SIS8300L Design Status

Frank Ludwig – DESY
for the LLRF Team

Starting Point - SIS8300_V2

(1) FPGA and RAM ----- (FL, 18.04.12)

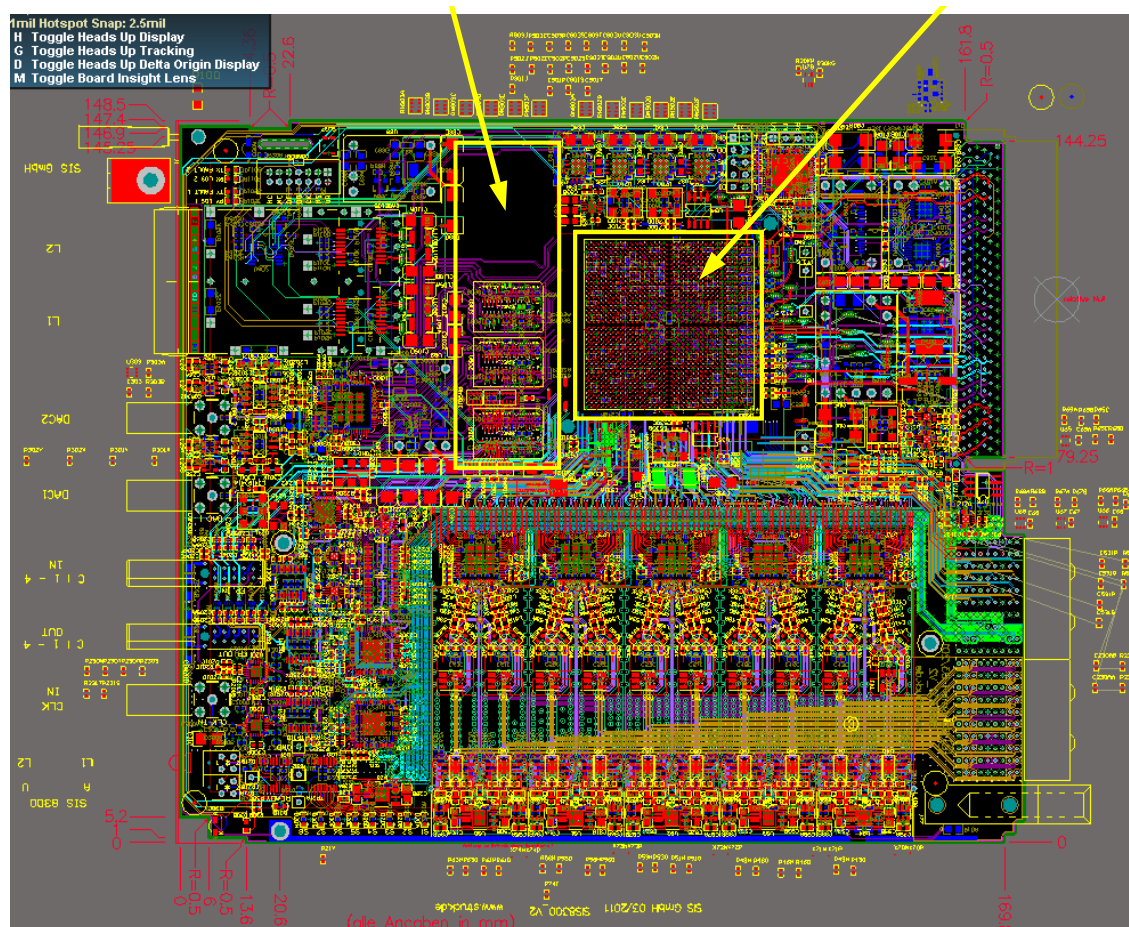
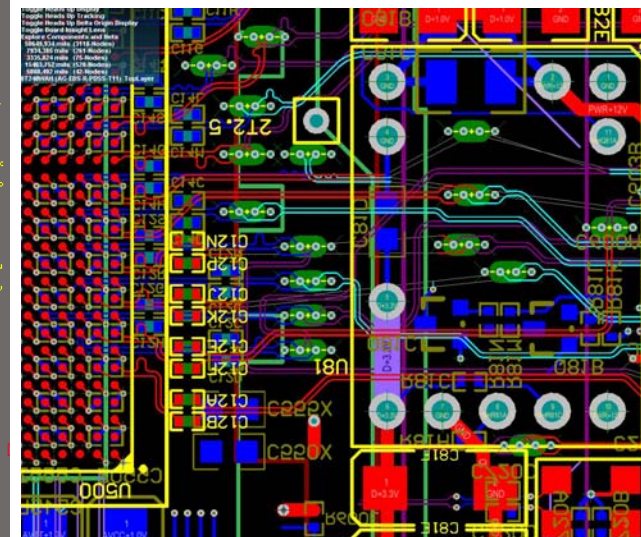
- ✓ FPGA has to be changed to type Xilinx Virtex 6 VLX130, 70% done
(more DSP slices, 3Gbps-> 6Gbps link, compatible to uTC V7)
- ✓ RAM has to be changed to DDR3 type 5x16 chips (Nanya NT5CB256M16BP-CG), 70% done

- 3Gbps -> 6Gbps (via feed throughs recommended from Xilinx) needs space

(2) Improving CMR ----- (FL, 18.04.12)

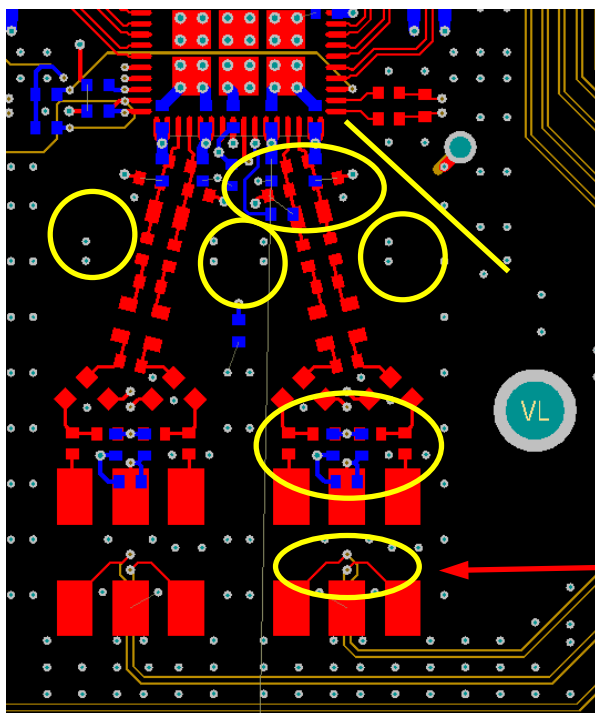
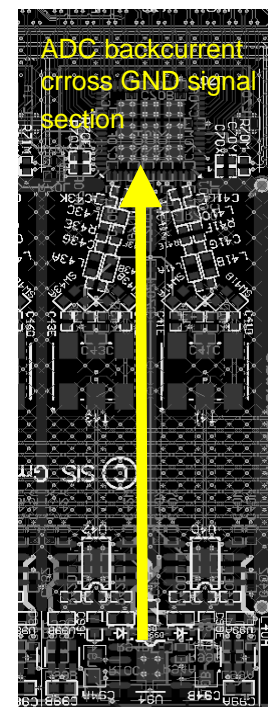
- ✓ - Replace 10x AC input transformer T41...T61 to TC1-1T+ (mini-circuits),
no universal footprint (improved CMR by >10dB due to better imbalance),
primary middle side not connected to GND
- ✓ - CLK shielded with more vias (yellow marked)
- ✗ - Improve differential signal routing symmetries (yellow marked)

can not rearranged
because of compatibility
to Z3 pin assignment

ADC backcurrent
cross GND signal
section

✗ can not realized
because of lack of space
on the AMC board

(3) Remove DC-length compensation ----- (FL, 18.04.12)

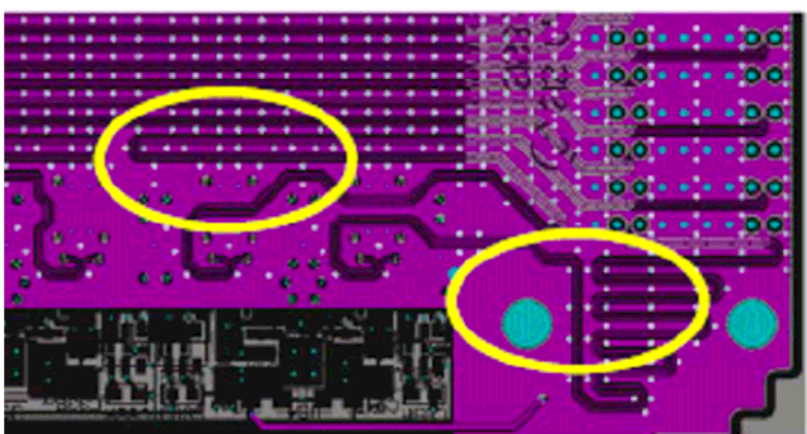
- ✓ - DC channel support stays, but all length compensation can be removed.

(5) (CLK crosstalk on channel 0,1,9) ----- is not proven by measurements ----- (FL, 18.04.12)

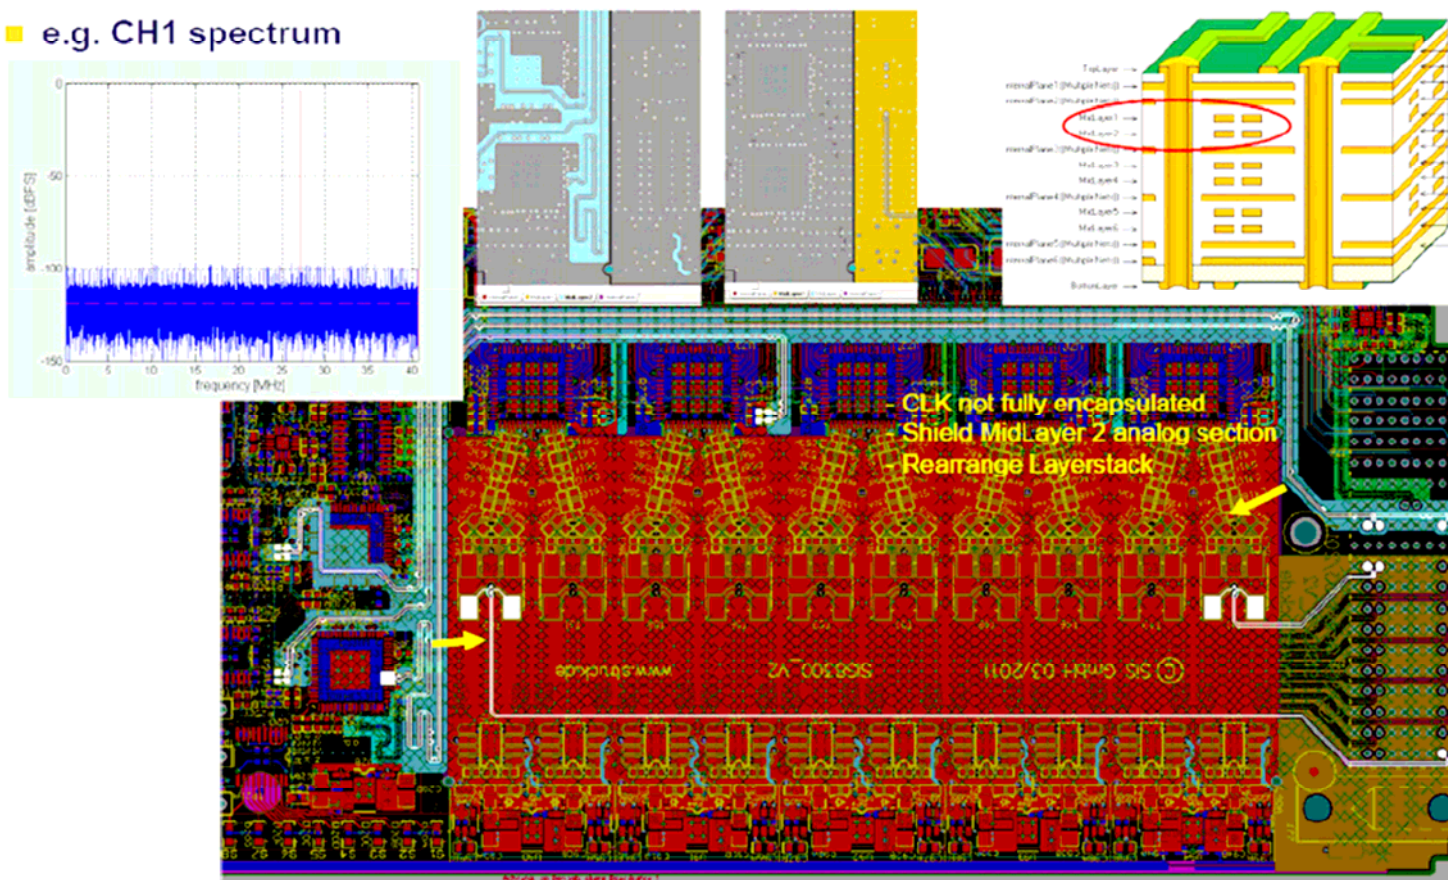
- ✓ - CLK has to be fully encapsulated
Shield Midlayer 2 analog section or layerstack rearrangement
- ✓ - Shield Midlayer 1 analog section within split plane using polygons

■ e.g. CH1 spectrum

(6) Reduce Transformer channel crosstalk ----- (FL, 18.04.12)

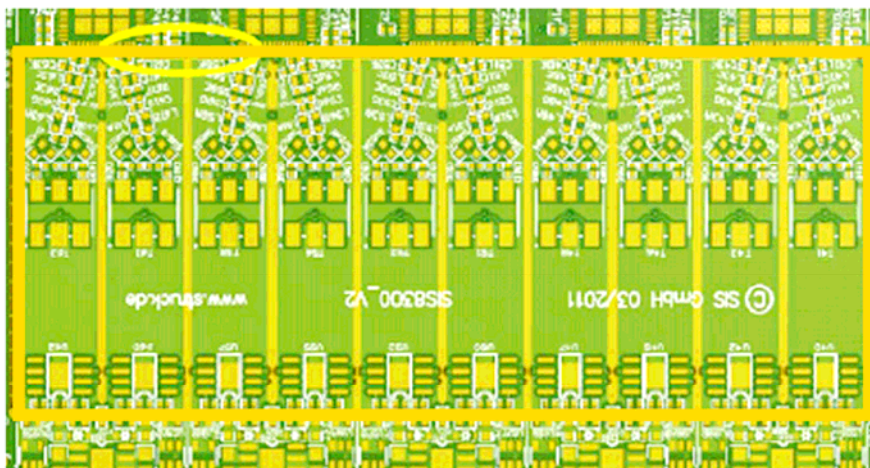
- ✗ - Wider solder stop and fixing wires for shielding on top
- Complete frame for solderstop tinplate housing (assembly option)

lack of space on the top side of the AMC board

(11) Compatibility to V5/V6/V7, SFP, P2P (LLL) ----- (FL, TJ 26.04.12)

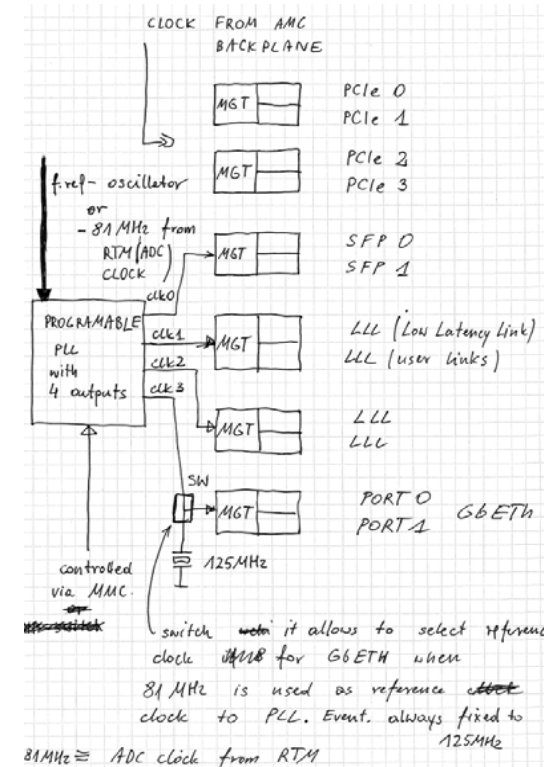
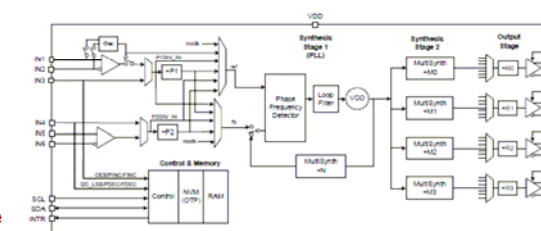
MGT frequencies at CLK0, CLK1, CLK2, CLK3 for V6 to V5,V6,V7 communication.
External operation for all CLKx outputs:
125.xxxxMHz x20 (40) = 3 GHz (6GHz), 20 or 40 is a factor in the PLL chip
106.5MHz
250.0MHz
2x81.25MHz x n = 3GHz(6GHz)
81.25MHz

There will be boards based on Virtex 5,6 and 7, so we need flexibility to be able to set a different link speed. This is valid for SFPs and P2P (LLL) links. Means clock divider or switchable oscillators have to be used.

✓ (13) Increase Split-plane distance for reduced rf-coupling ----- (FL, 07.05.12)

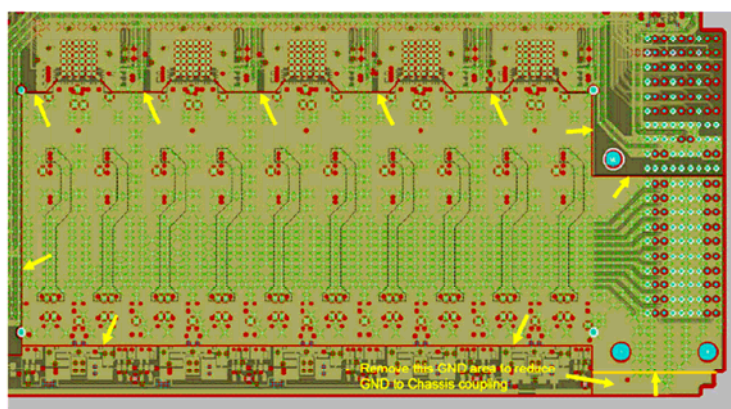
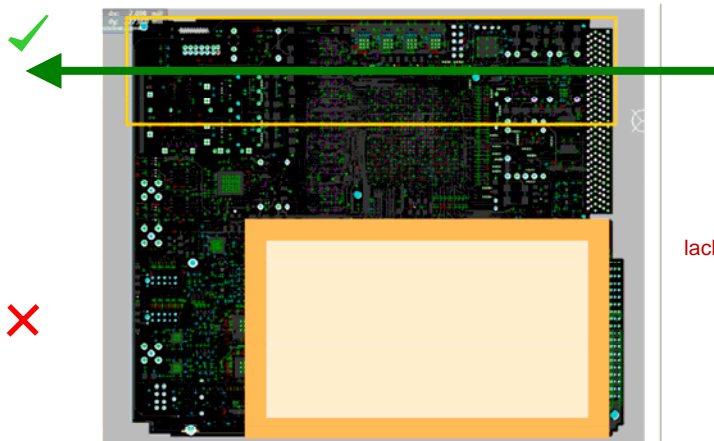
- Increase slit of the GND signal area from 0.29mm to 1mm
- Change the split plane near the guiding pin to reduce GND to chassis coupling

- Add more Multilayer Vias in the marked zone (top box) for bypassing Chassis to GND distortions from the ADC signal zone. Digital back currents will flow back more on top side.

lack of space on the AMC board.
